TECHNICAL NEWS

Bulletin Nbr: 99-02-855a

Locking mechanism, tailgate

Saab 9-3 M98 - M99 up to and including VIN X2053929.

D855B603

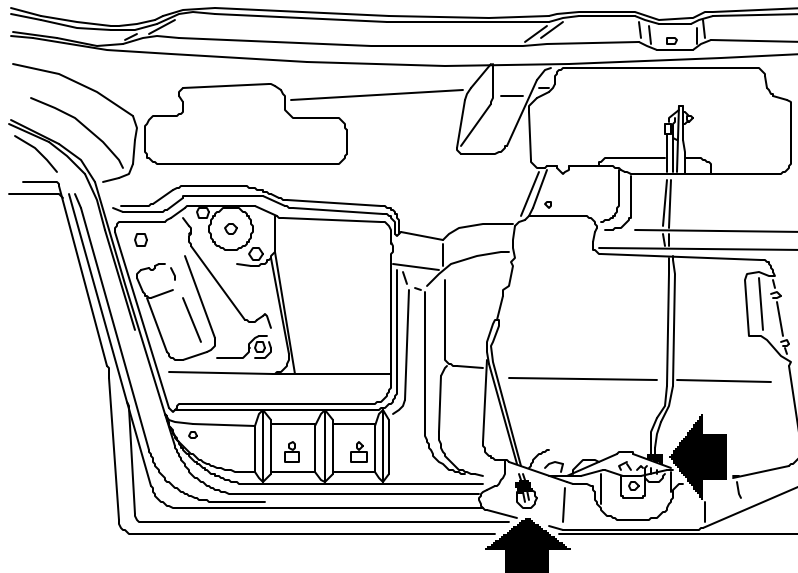
The tailgate on certain cars has occasionally been difficult to open due to a few defective clips. If a clip falls out when the tailgate is locked, it will remain locked. If the clip falls out when the tailgate is open, it can not be locked again.

Replace the black clip with the blue one. Remove the interior handle from the tailgate trim, remove four black clips, bend out the trim carefully, grasp the lock arm and press it down. This will unlock the tailgate. Go to the back of the car and open the tailgate, remove the trim and replace the clip. See illustration. Fit the tailgate trim and the interior handle.

If the clip securing the link arm to the lock cylinder is broken, it may be necessary to remove

the locking mechanism in order to replace the clip.
